UNITED STATES OF AMERICA  
NUCLEAR REGULATORY COMMISSION

In the Matter of )  
DAIRYLAND POWER COOPERATIVE ) Docket No. 50-409  
(La Crosse Boiling Water Reactor) ) (FTOL Proceeding)

APPLICANT'S RESPONSE  
TO  
LICENSING BOARD QUESTIONS

FIGURE NO. 1 - ACTUAL TOTAL ATMOSPHERIC  
RELEASES OF I-131 FROM  
LACBWR

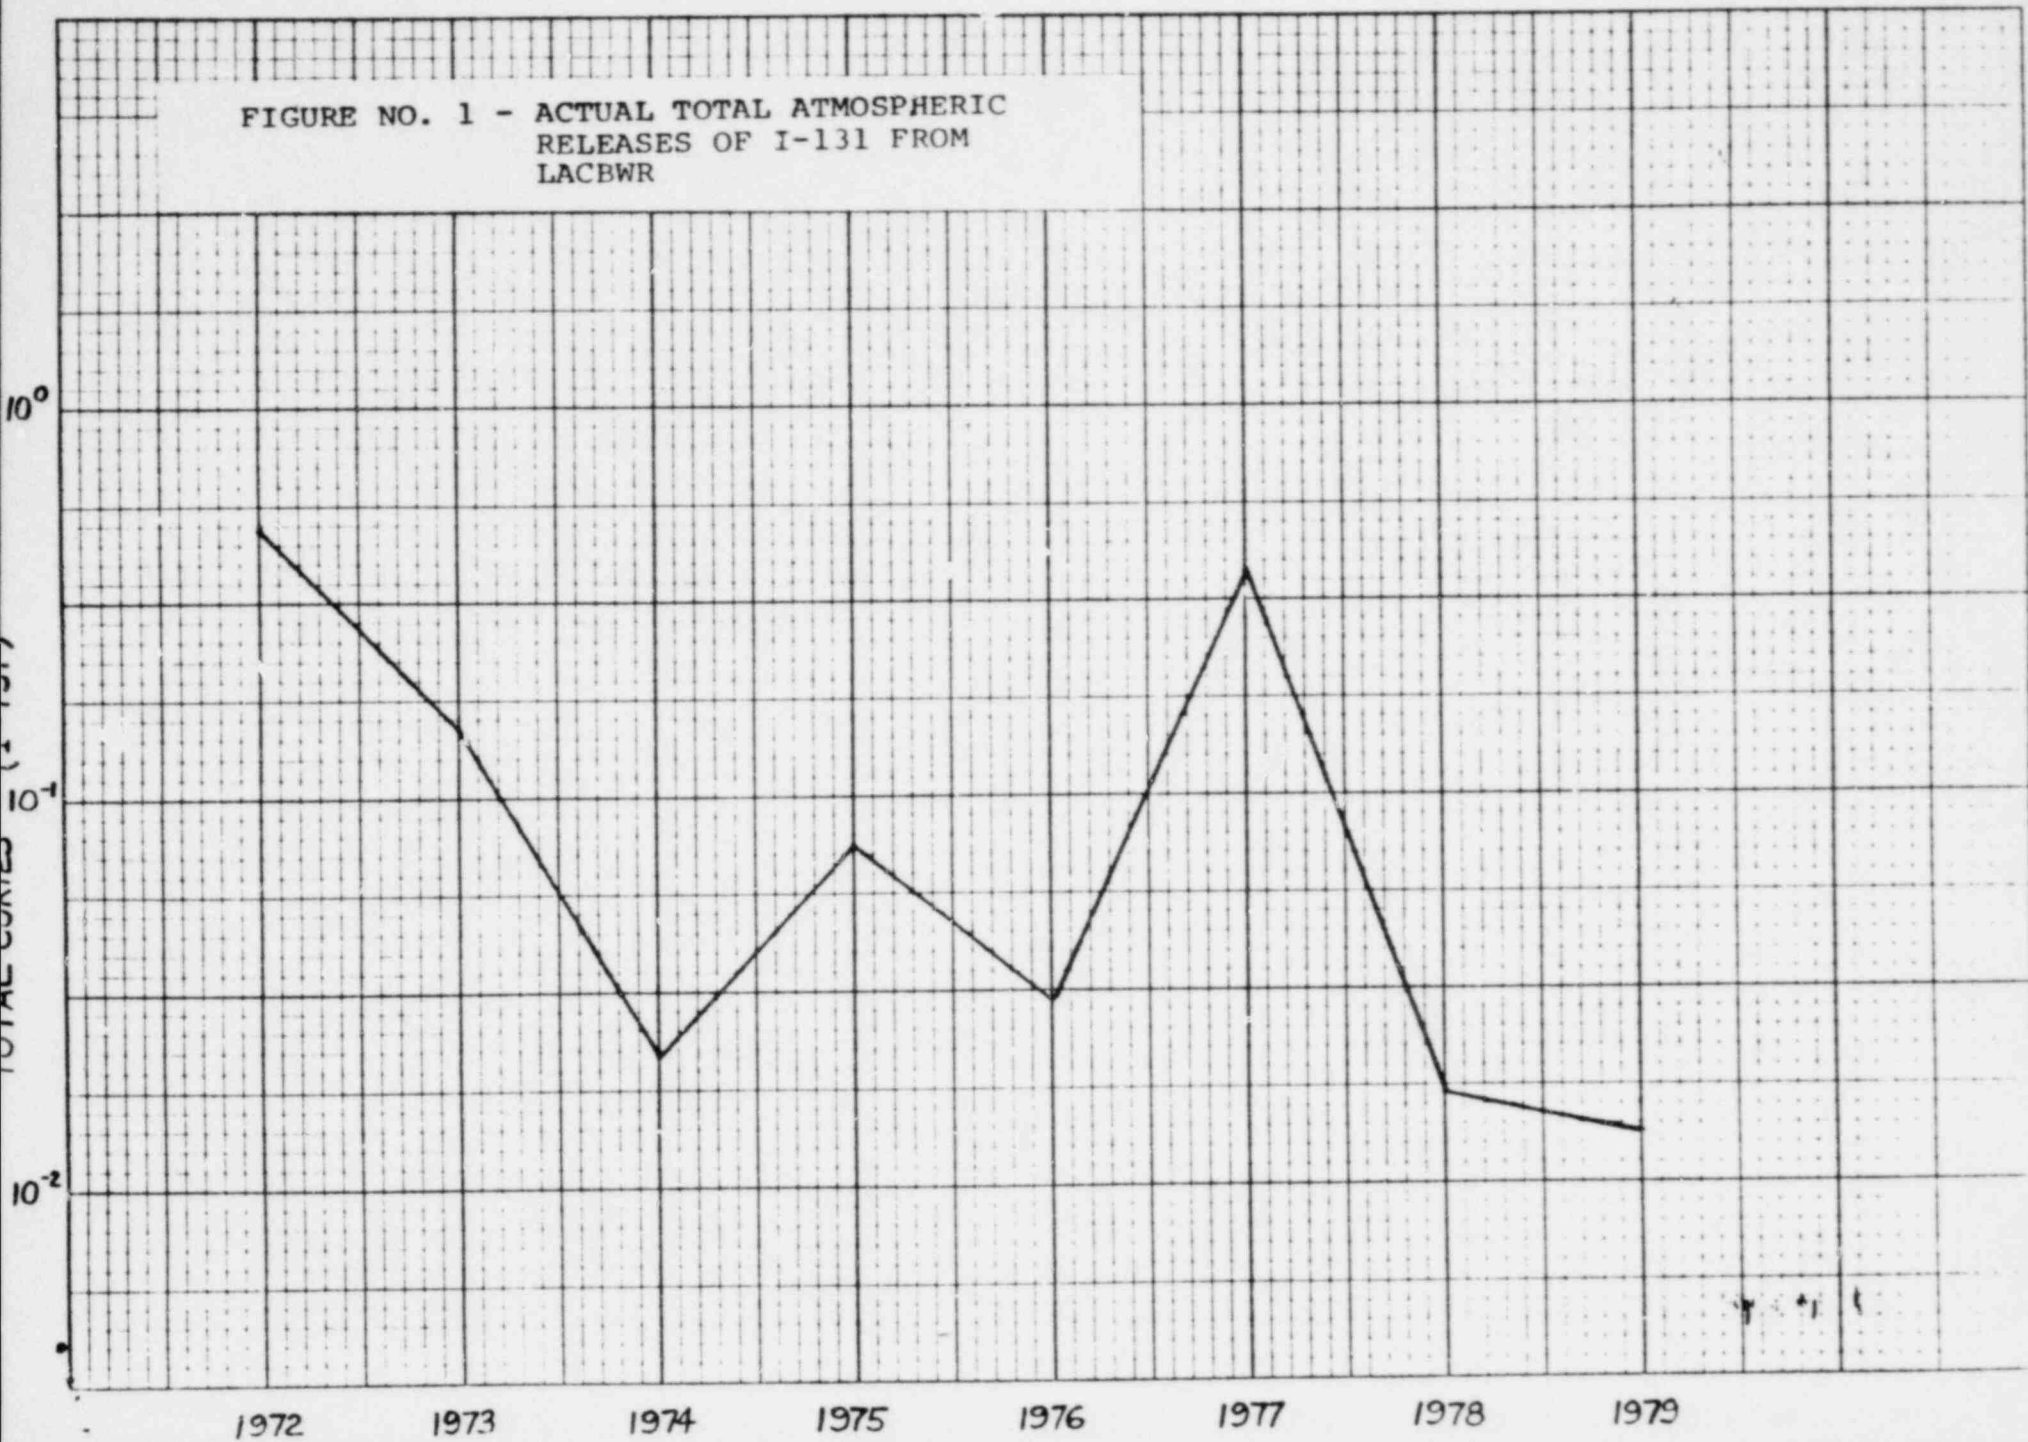
With respect to Contention 2A, regarding off-gas emissions, there appear to be some discrepancies in the radiological release figures provided in the FES. The Staff's evaluation of releases of radioactive material in gaseous effluents is based on the period 1978-79, whereas the Applicant's higher estimates for noble gases, I-131 and particulates are based on actual releases during early 1977. On the other hand, EPA estimates that releases of I-131 may be considerably higher (FES, p. A-10). The Board desires a reconciliation of these estimates and, in any event,

a listing of actual annual releases of gaseous effluents (particularly I-131) throughout the life of the plant. The Board also wishes an explanation of why the years used by the Staff (1978-79) as a basis for estimates are more appropriate than those used by the Applicant or EPA, which apparently reflect higher release values. Please describe in detail any mechanical or operational changes in the facility which may justify using the years chosen by the Staff.

By letter dated June 13, 1980, DPC provided the Licensing Board with copies of the LACBWR Effluent Reports and Environmental Monitoring Reports for the years 1972-1979. In addition, a graph showing actual I-131 releases from LACBWR for the years 1972 through 1979 is provided in Figure 1. The graph shows that during the years 1978 and 1979, the actual I-131 atmospheric releases from LACBWR decreased by a factor of approximately 15.0 compared to the I-131 releases during 1977, and decreased by a factor of 16.0 compared to the average total I-131 atmospheric release for the years 1972 through 1977.

The primary reason for the reduced I-131 release during 1978-1979 was the completion of modifications to the offgas treatment system in 1978 referred to earlier. This augmented offgas system is described on Page 3-13 of the FES. A simplified drawing of the gaseous waste and ventilation systems is provided in Figure 3.6-2 of the FES. Basically, the augmented offgas system handles air ejector gases from the main condenser. The augmented system includes a catalytic recombiner, two in-series 1600 ft<sup>3</sup> waste gas storage tanks, and an additional combination HEPA filter and charcoal absorber. This system allows increased holdup and decay of shorter lived noble gases prior to release to the 350-foot stack. Additional I-131 removal is also achieved by the charcoal absorber. Further, the combined removal of H<sub>2</sub>O with the recombiner systems and added charcoal absorber increases the holdup and decay of halogens (including I-131) prior to release to the stack. The net result of using this system is a reduction in the atmospheric release of fission gases, including I-131.

Figure 2 - MAN-REM OCCUPATIONAL EXPOSURES  
 AT SEVERAL SMALLER BWR PLANTS  
 (BASED ON NUREG-0594)

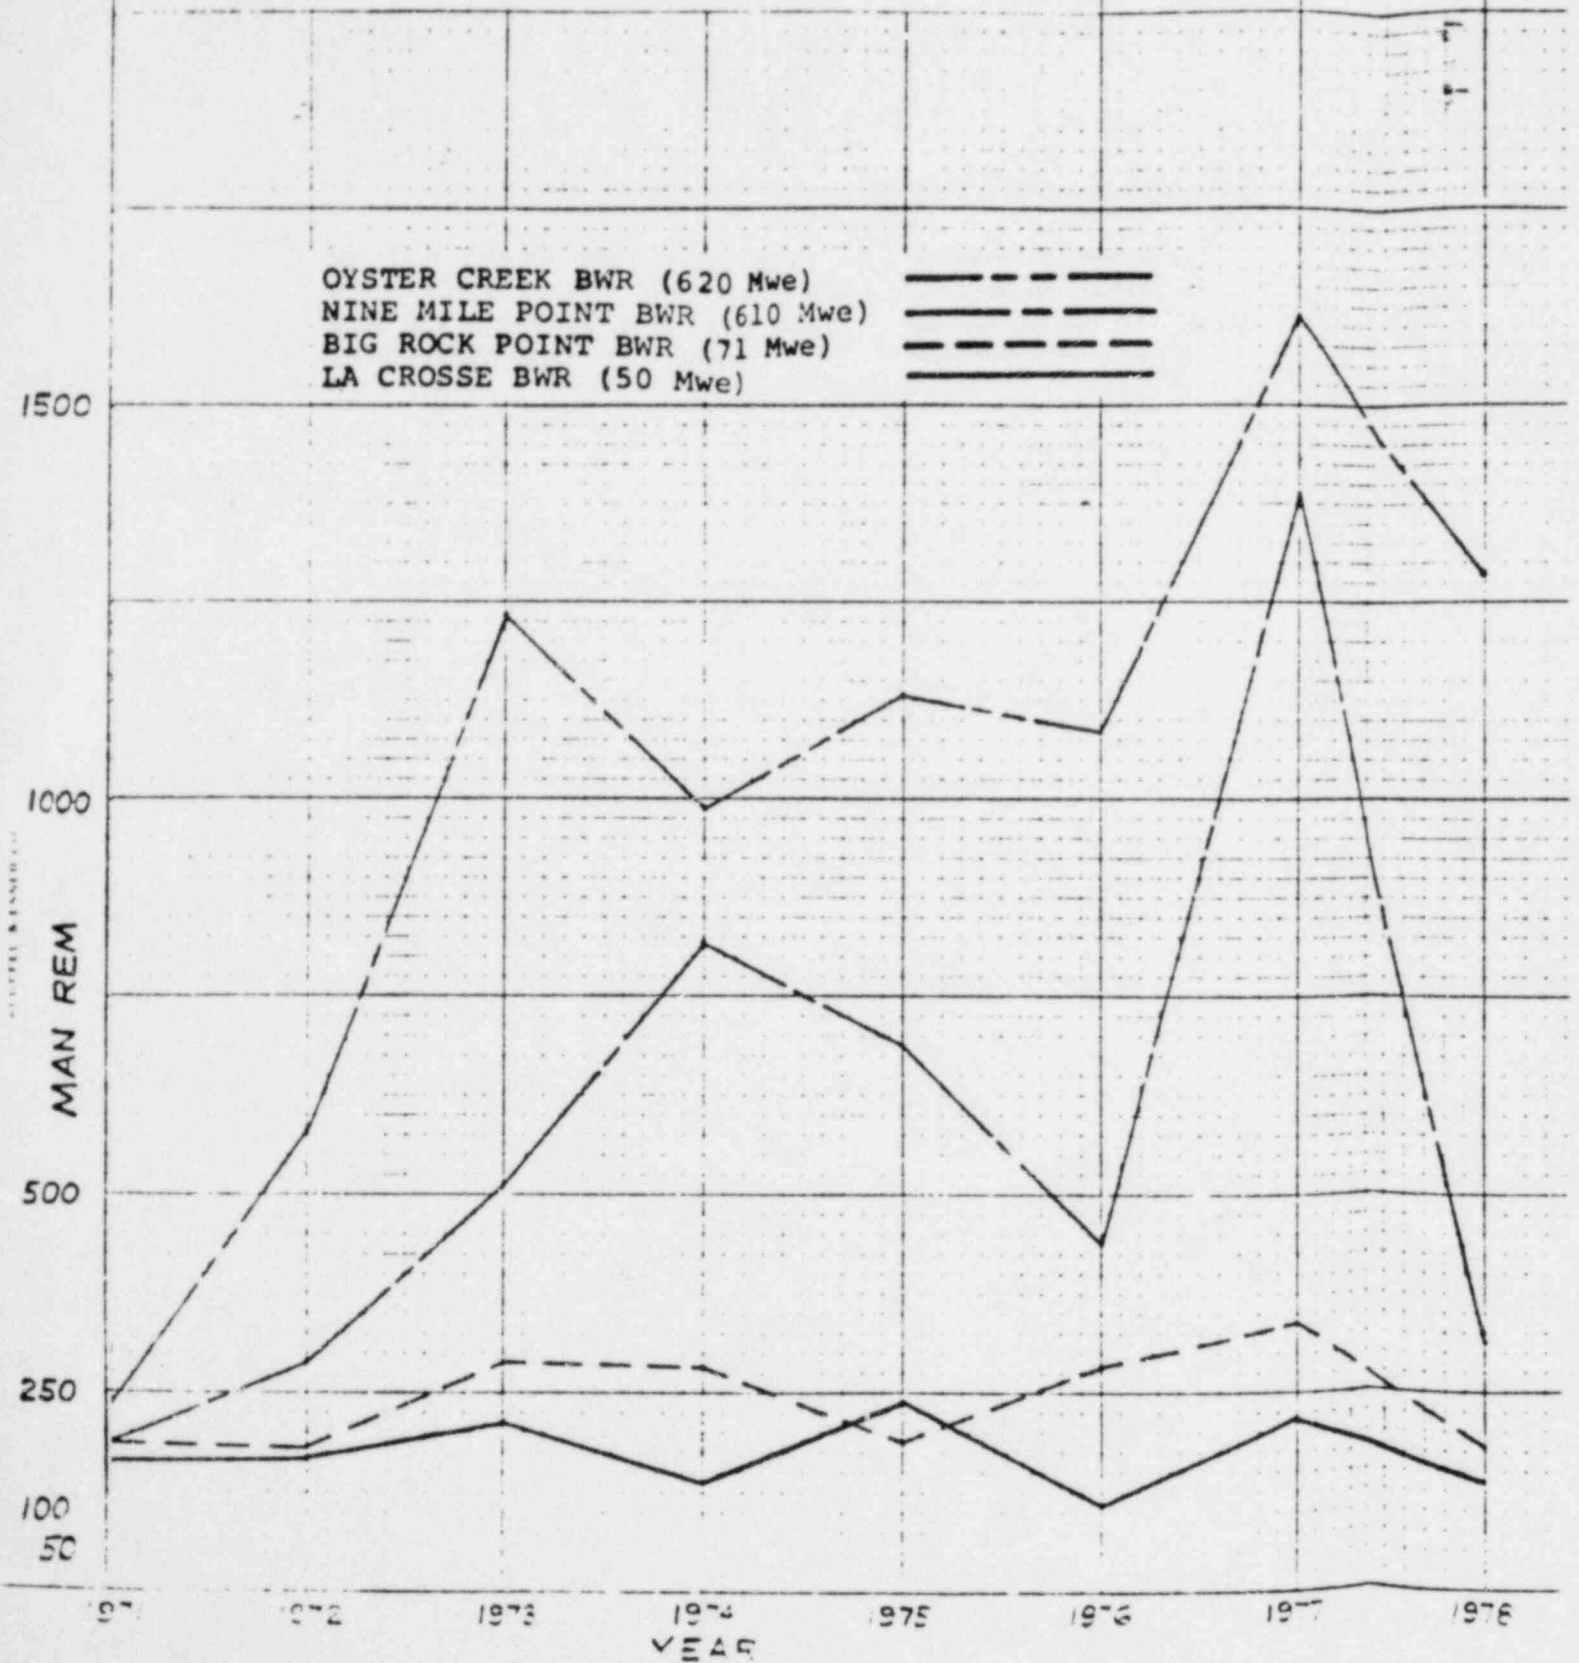
With respect to Contention 2B, regarding occupational exposure of workers, the FES includes a number of figures which appear to call for further explanation. For instance, it lists 156 man-rem/year as the average LACBWR occupational exposure for the years 1970-1978 (§ 5.5.2, p. 5-12). In contrast, it lists 600 man-rem/year/reactor unit as general past exposure experience (without defining which reactors and which years are included) (Id.). At the spent fuel pool hearing, however, the Staff testified that the annual worker exposures of LACBWR ranged from about 110 to 240 man-rem (Shea, direct testimony, p. 4, fol. Tr. 893). Moreover, the Staff's Environmental Impact Appraisal prepared in conjunction with the spent fuel pool expansion proceeding suggested that occupational exposures with the additional spent fuel might be 1% higher than earlier annual man-rem exposures (EIA, § 8.1.2).

The Board wishes to be provided with a listing of the annual man-rem occupational exposures at LACBWR throughout its operation and an explanation for any years during which exposures were significantly above the predicted average of 156 man-rem. The Board also wishes to be provided with an analysis of man-rem exposures at reactors of varying sizes and an explanation as to how the predicted occupational exposure of 156 man-rem may be considered ALARA in view of the relatively small size of LACBWR and the relatively lower number of employees at LACBWR compared to larger reactors. In addition, the Board wishes to be advised why average occupational exposures at Big Rock Point, Nine Mile Point, and Oyster Creek have apparently been lower than at LACBWR and whether measures used at those plants might possibly be adopted at LACBWR.

NUREG-0594 contains data concerning the following exposure parameters for all operating commercial nuclear power plants in the United States: (1) total man-rem, (2) average rem/man, and (3) man-rem per megawatt year, for the years 1971 through 1978. The data for relatively smaller BWR's (i.e., LACBWR, Big Rock Point, Nine Mile Point, and Oyster Creek) are presented in Table 1. In addition, the total man-rem for these four power plants for the years 1971-1978 are plotted in Figure 2. Table 2 provides the total man-rem ranges for the four plants for years 1971-1978.

The man-rem variances, as shown in Table 2, for LACBWR and Big Rock Point (the two smallest BWR's) for the years 1971-1978 are relatively small. LACBWR has a range of 111 to 234 man-rem/year, and Big Rock Point has a range of 175 to 334 man-rem/year. There is no indication of a man-rem increase with plant age for either LACBWR or Big Rock Point. However, Table 2 shows that man-rem variances for Nine Mile Point and Oyster Creek (two 600 MWe BWR's) for the years 1971-1978 are relatively large. Nine Mile Point has a range of 195 to 1383 man-rem/year, and Oyster Creek has a range of 240 to 1614 man-rem/year. In the case of Oyster Creek, as well as larger BWR plants, there appears to be an indication of man-rem increases with plant age as reported in NUREG-0594.

Figure 3

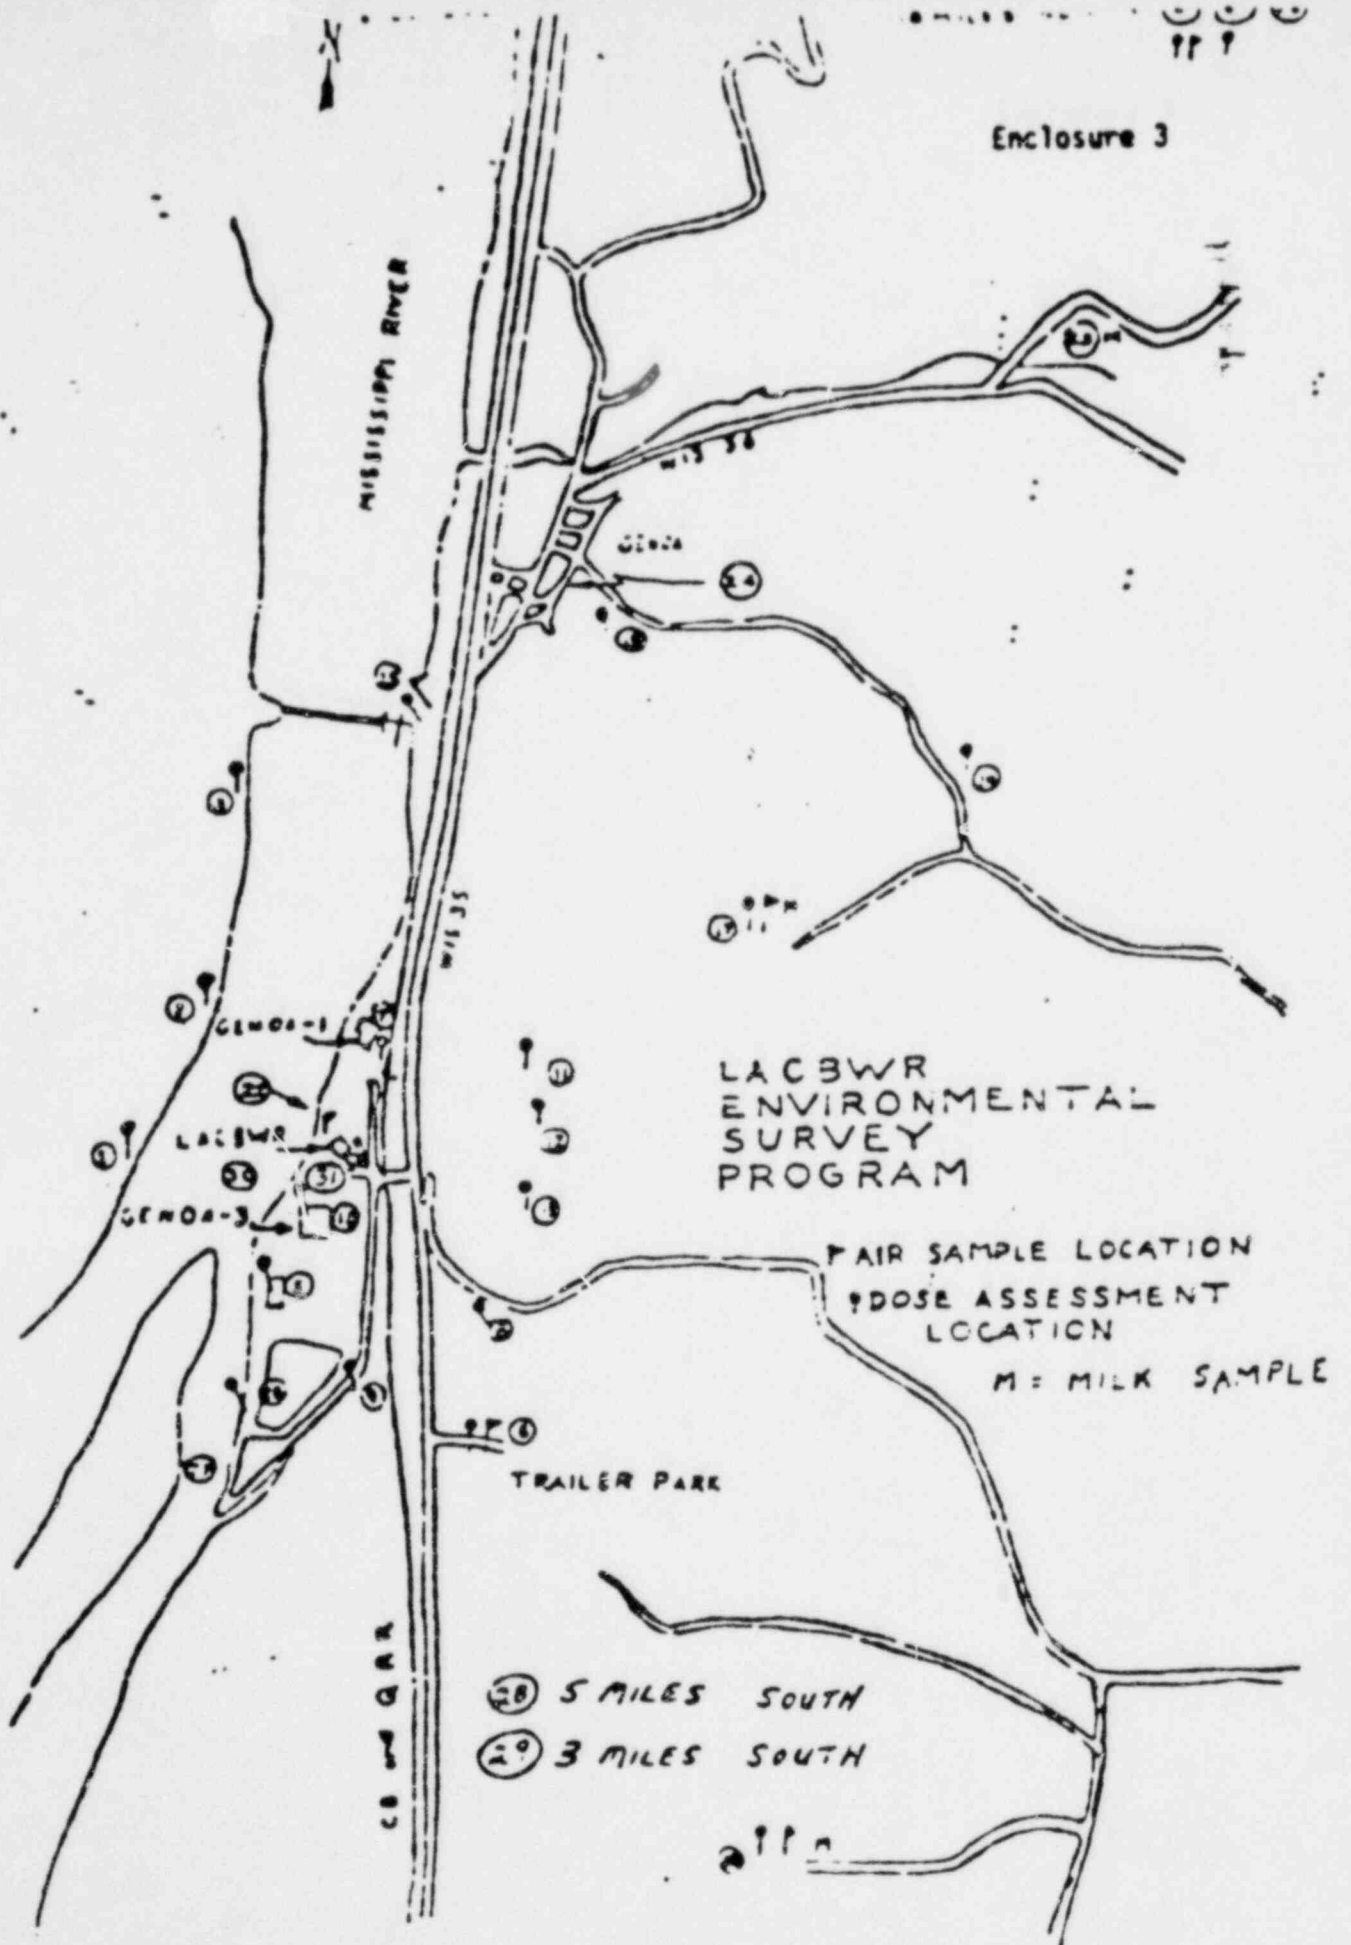
With regard to Contention 8, concerning environmental radiological monitoring, the FES suggests that the monitoring which is being provided is that required by Regulatory Guide 1.21 (see FES § 6.4). The latest revision of that Guide apparently is dated June 1974. However, the Board is aware that the Department of Health, Education and Welfare, Public Health Service, commented critically on the operational off-site radiological monitoring program (FES, p. A-4) and that the Staff declined to respond to those comments (FES, § 11.6, p. 11-8). The Board is also aware that new and additional guidelines for environmental radiological monitoring have recently been developed and provided to both licensees and operating license applicants. See Branch Technical Position (BTP), Revision 1 (November 1979) of Radiological Assessment Branch, provided to licensees by letter from W. P. Gammill, dated November 27, 1979, and to operating license applicants by letter from Steven A. Varga, dated December 21, 1979. (This BTP apparently updates Regulatory Guide 4.8, which was referred to in the DES but has been deleted from the FES.)

The Board wishes to be provided with a complete description of the environmental radiological monitoring program and apprised as to whether, and if so in what manner, DPC will comply with the requirements of the foregoing BTP, Revision 1, the Board should be provided with explanations as to why particular provisions of the BTP, Revision 1, are not to be followed.

NRC Regulatory Guide 1.21 deals with effluent monitoring. The DPC environmental monitoring program for LACBWR conforms with the requirements of Regulatory Guide 4.8 as well as the Branch Technical Position (BTP), Revision 1 (Nov. 1979) of the NRC Staff. Radiological Assessment Branch, as described in some detail in Dr. Branagan's Affidavit submitted in support of the NRC Staff's Motion for Summary Disposition, dated June 6, 1980. An outline of the DPC environmental monitoring program, listing the type, frequency, location and analysis for each sample taken is contained in Tables 3 and 4. The sampling locations are shown on Figure 3.
